CITY OF CODY
PLANNING, ZONING AND ADJUSTMENT BOARD
TUESDAY, APRIL 11, 2017
CITY HALL COUNCIL CHAMBERS @ 12:00 NOON

**CITY OF CODY
PLANNING, ZONING AND ADJUSTMENT BOARD
STAFF REPORT**

MEETING DATE:	APRIL 11, 2017	TYPE OF ACTION NEEDED	
AGENDA ITEM:		P&Z BOARD APPROVAL:	X
SUBJECT:	SITE PLAN REVIEW: LIQUOR STORE. SPR 2017-10	RECOMMENDATION TO COUNCIL:	
PREPARED BY:	TODD STOWELL, CITY PLANNER	DISCUSSION ONLY:

MEETING DATE:	APRIL 25, 2017	TYPE OF ACTION NEEDED	
AGENDA ITEM:		P&Z BOARD APPROVAL:	X
SUBJECT:	SITE PLAN REVIEW: TEMPORARY CELL ON WHEELS TOWER SPR 2017-09	RECOMMENDATION TO COUNCIL:	
PREPARED BY:	TODD STOWELL, CITY PLANNER	DISCUSSION ONLY:

1 NORTH ELEVATION

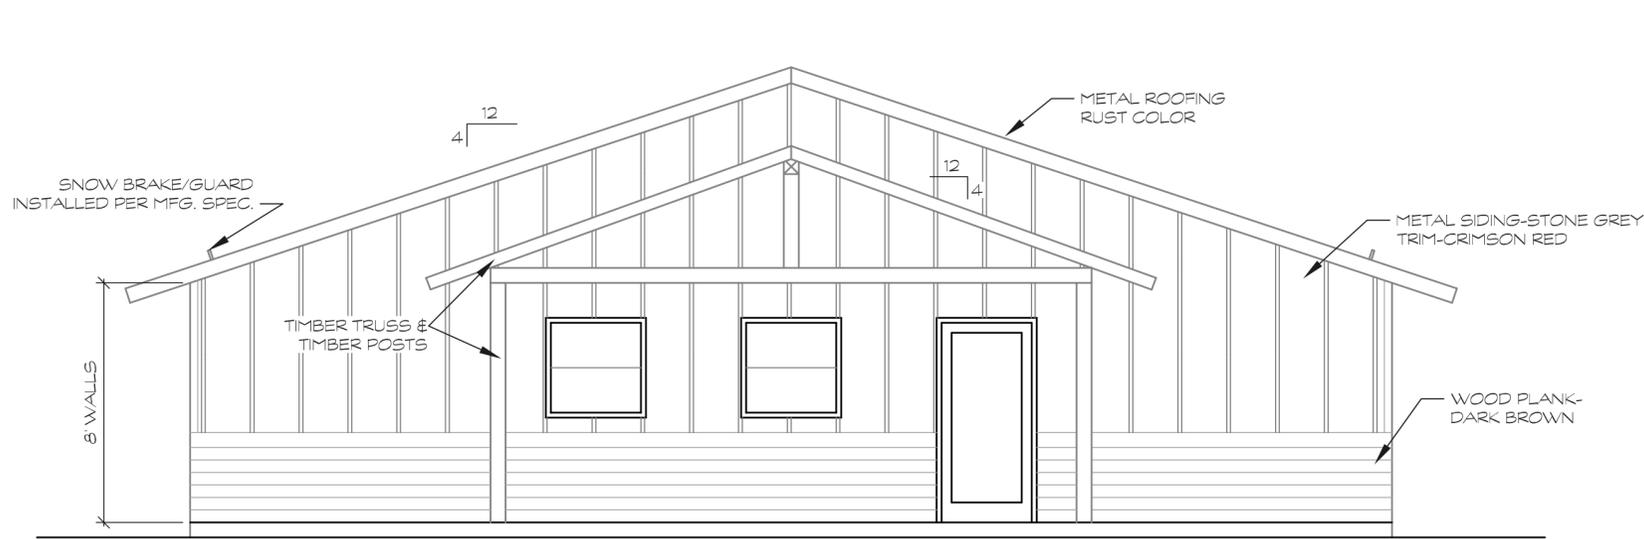
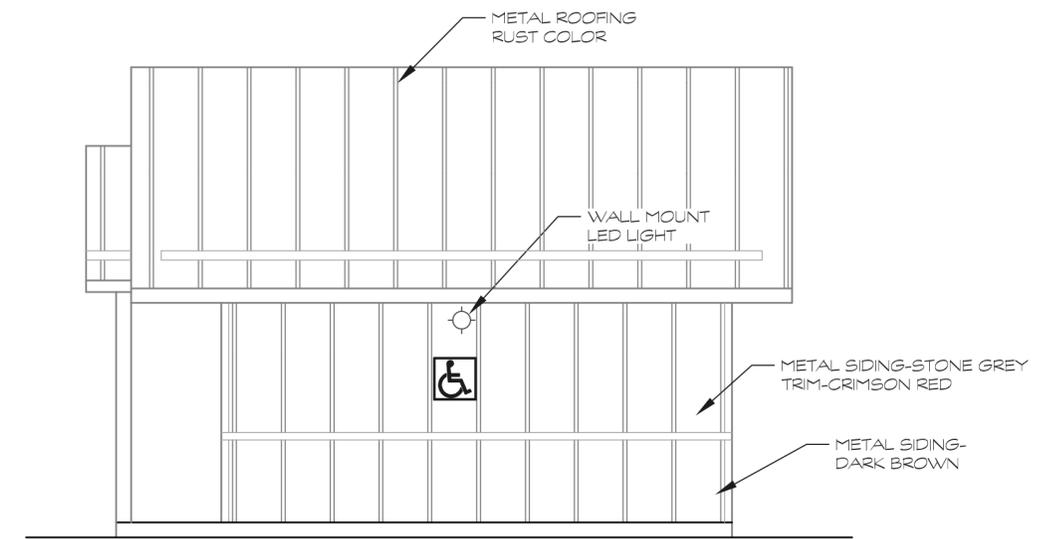
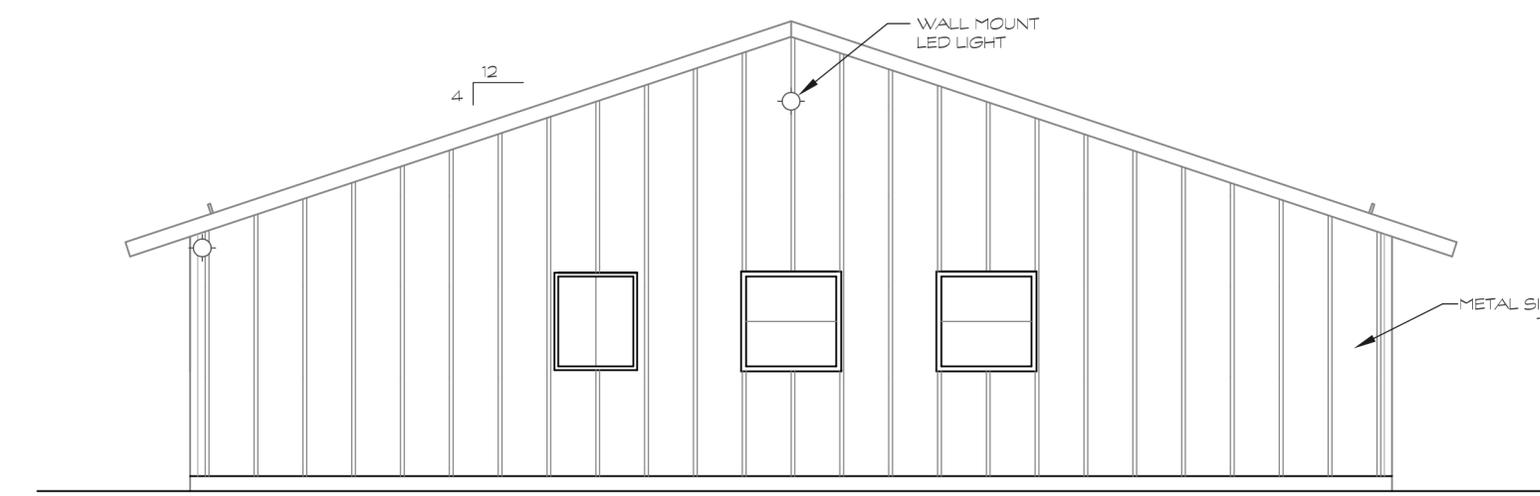
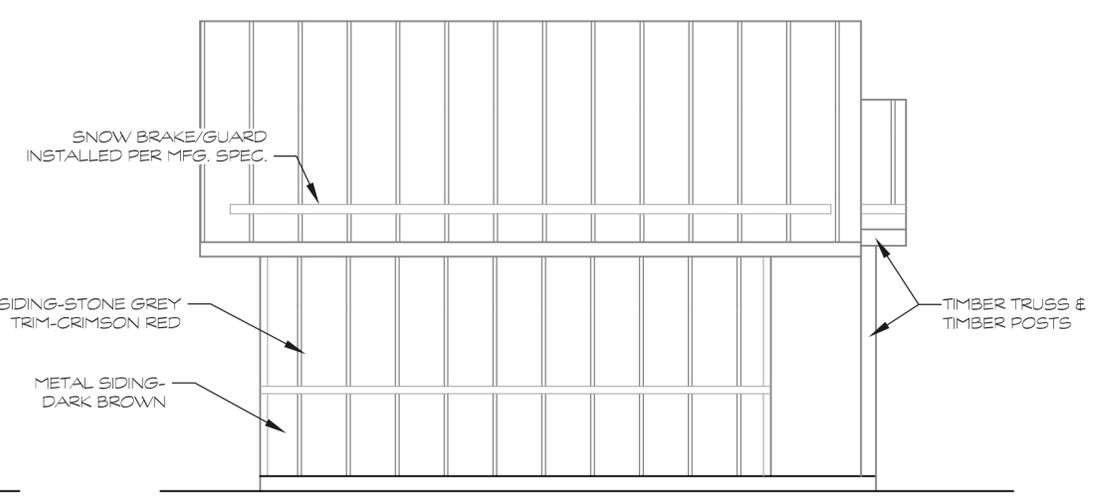
The architecture of the building is described in the attached drawings. The roofing material is metal in a rust color (Cor-ten? rust-in-place?). Siding on the building is vertical metal paneling, with the exception of a natural wood wainscot proposed on the front of the building. The wainscot concept on the ends of the building is through the use of a dark brown metal siding on the lower portion of the wall and a stone-grey colored metal siding on the upper portion. Trim color is crimson red.

The front elevation is enhanced through an open-timber style canopy. The wood wainscot concept is borrowed from the Sherwin-Williams building down the street. Cort-ten roofing is relatively popular and used on a number of new metal buildings in the City. The stone-grey and red colors match the building at Joe's Auto. Not having a photo rendering or swatch with all the colors together, it is difficult to visualize whether all of the colors would match well together.

The Board will need to determine if the architectural components of the building are acceptable.

1 SITE PLAN

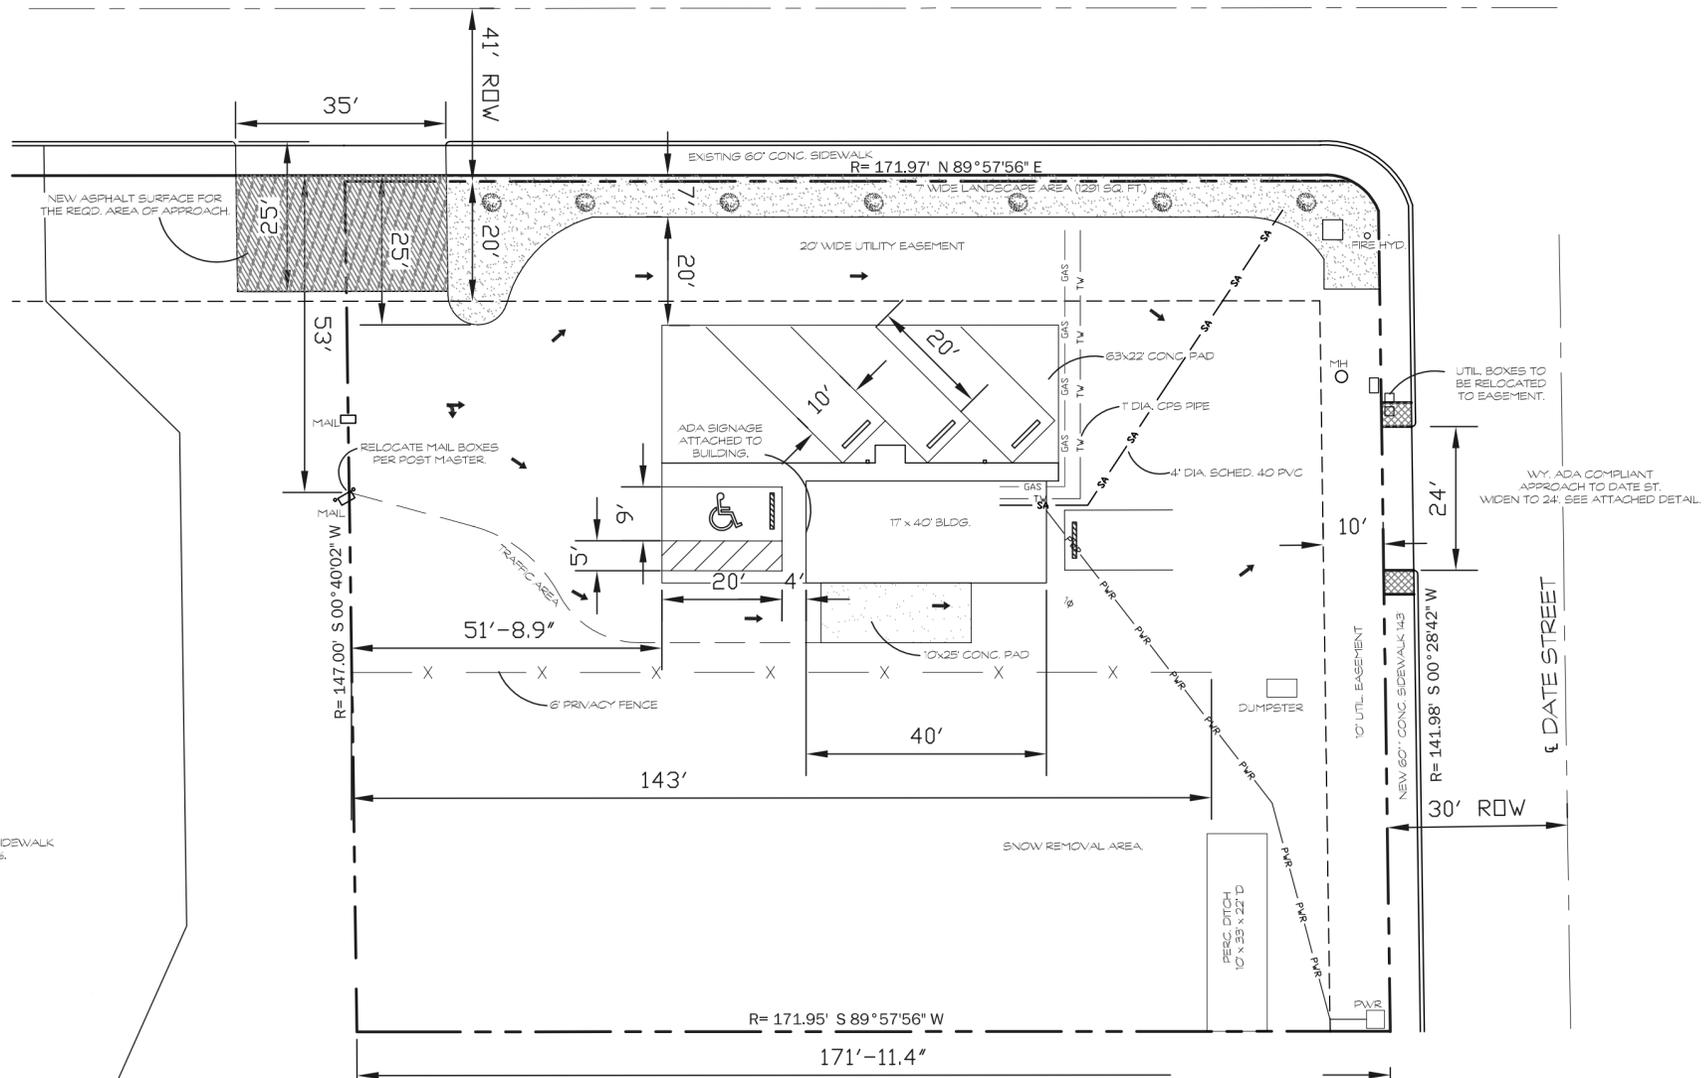
The applicant has worked with staff on the access and parking layout, such that the current plan meets minimum dimensional standards, provided the ADA space is designated as van-accessible and widened to 11 feet. The required paved entrance is shown on Big Horn Avenue, and the Date Street approach is widened to 24 feet.

As the Big Horn Avenue approach is a shared approach, a shared access easement should be established over it.

The snow storage area is shown in the southeast portion of the property, and it is noted that area in the northeast and southeast corners would also be available.

The dumpster location is at the east end of the fence, which appears acceptable.

4. Any exterior lighting fixture visible from Big Horn Avenue must be recessed or full cut-off in style.
5. Modify the ADA space to be 11 feet wide to meet van-accessible requirements, and include appropriate signage.

6. A city encroachment permit must be obtained by the contractor for work within the Date Street right of way.
7. An easement or other legal agreement must be established for the shared approach/drive prior to occupancy of the building. Use of the shared approach by this property must be verified by WYDOT.

1 SITE DRAINAGE

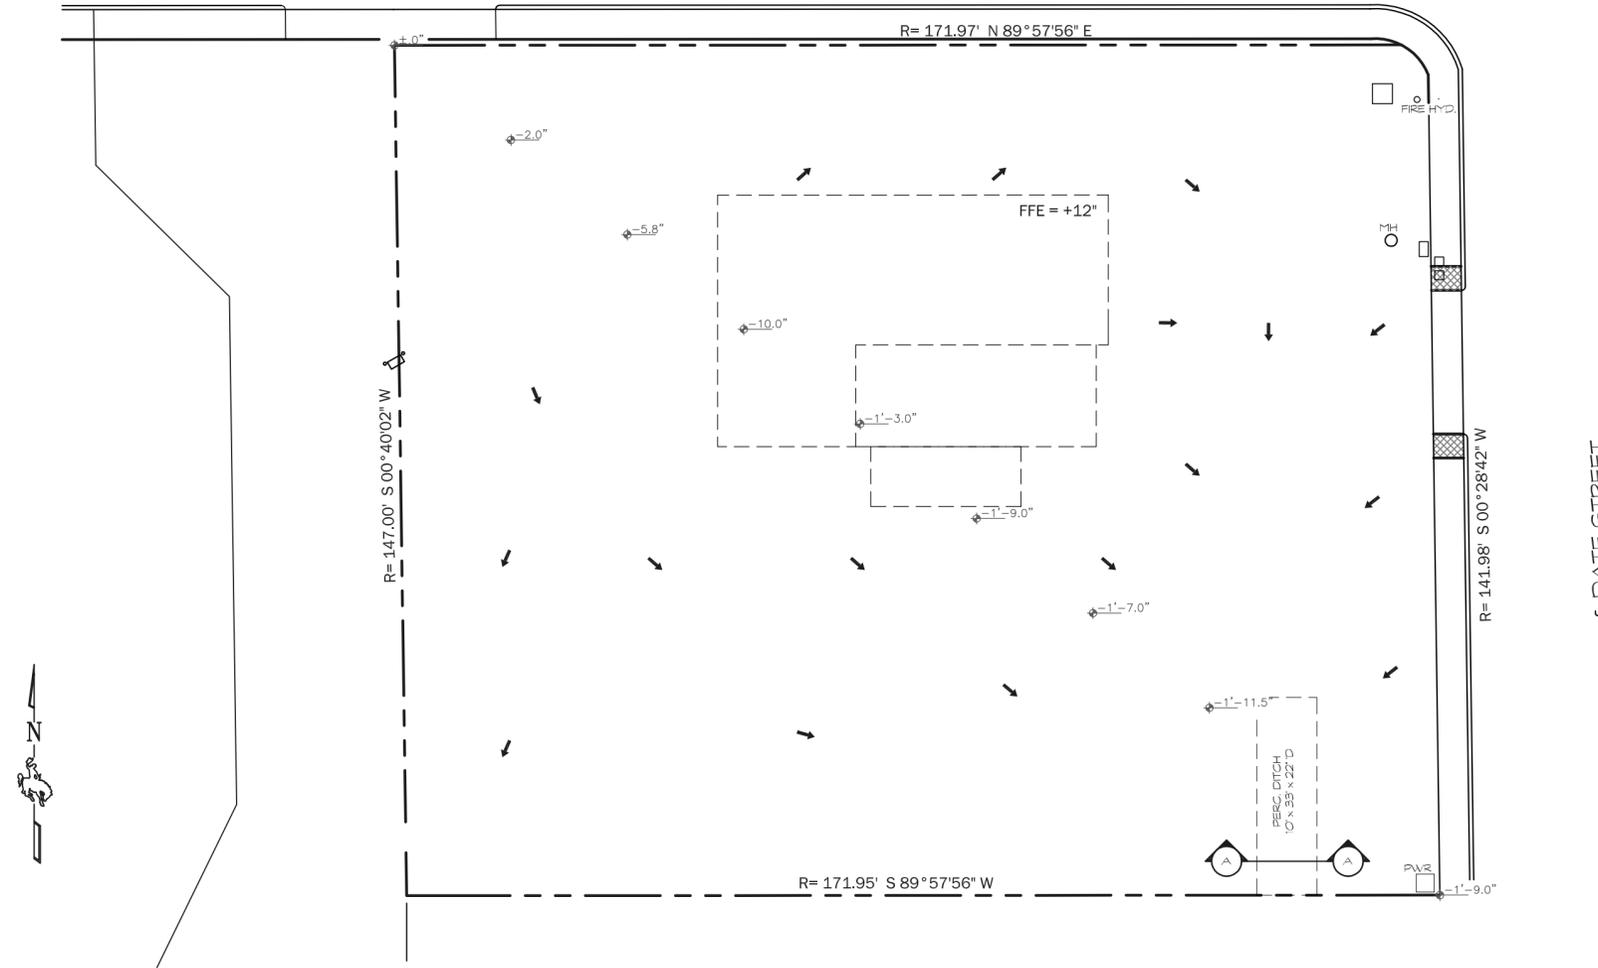
Because the total amount of impervious surface on the lot is less than 5,000 square feet (4,870 sq. ft. proposed), an engineered storm water plan is not required, provided the amount of retention identified in the City's storm water manual is provided. Staff calculated the required size of the infiltration swale to be 15 feet wide and 33 feet long, using the 22-inch depth specified on the plans. In addition, we suggest the swale be turned 90 degrees and shifted to the south property line.

The general grading plan has been provided on the "Site Drainage" sheet. The requirement is that storm water be able to flow towards and into the infiltration swale. Due to the slope of the property, it appears that this can be accomplished, although specific grading details are lacking. Staff can field verify the grading of the site as part of the construction process.

1. Modify the infiltration swale to be 15' by 33' and 22 inches deep, or an equivalent capacity authorized by the City engineer. Provide the 3:1 side slopes as proposed. The swale should be turned 90 degrees and moved towards the south property line.

2. The applicant and staff shall field verify the proper grading of the site as part of the construction process.
3. Any applicable city utility fees (water, sewer) are to be paid prior to building permit issuance—coordinate with Public Works.

TITLE:
**3100
TOWER/TRAILER**

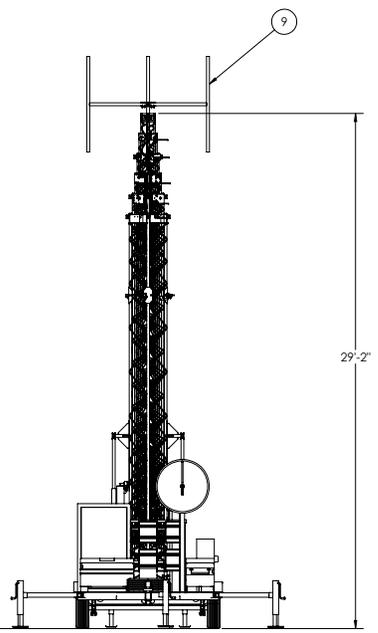
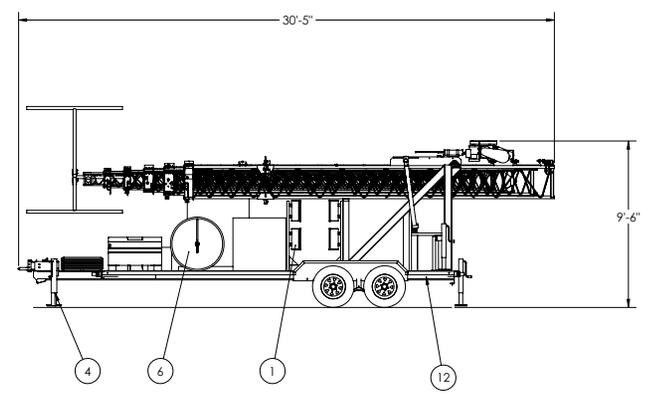
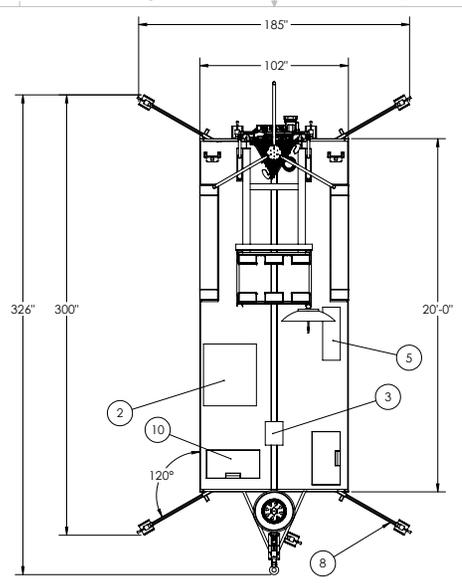
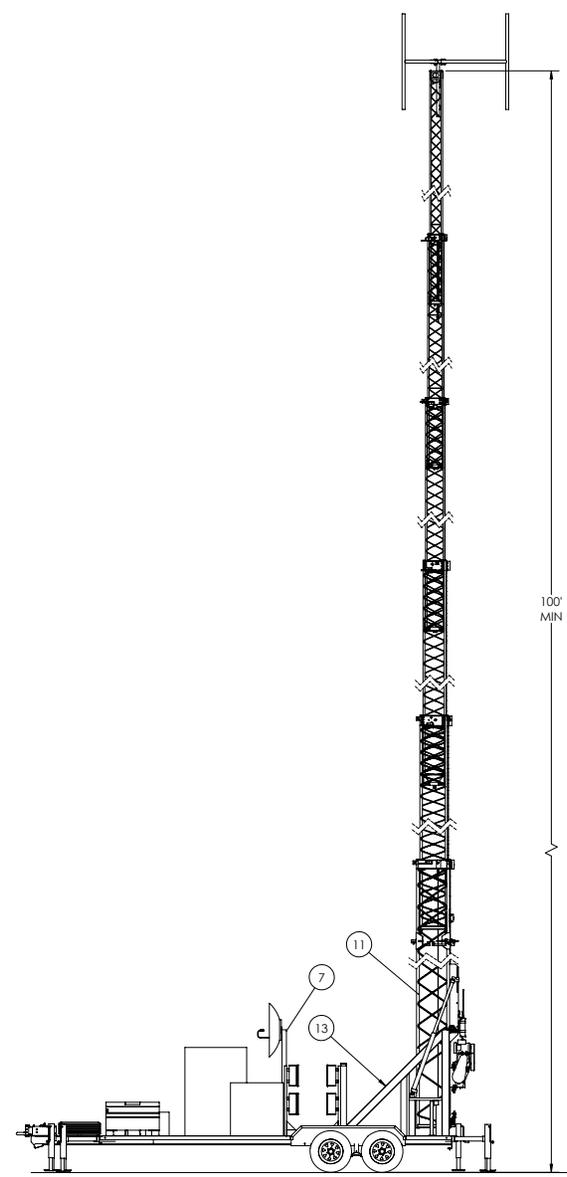
There is not much that can be done architecturally with a temporary cell on wheels other than ensure the height is no taller than necessary, consider screening of the ground equipment if there is a visual concern, and prohibit any lighting unless specifically required by FAA. With the height proposed, no lighting is anticipated to be required.

No signage, other than required safety notices, is proposed. Logos or other signage should not be displayed on the tower.

1. Authorization of the facility shall expire May 31, 2018, after which the facility shall be removed from the property.
2. No logos or other advertising signs are permitted on the communication tower and antennas.
3. Lighting of the communication tower is not authorized, unless specifically required by the FAA.
4. The project must otherwise comply with the submitted plans and applicable building, fire, and electrical codes.
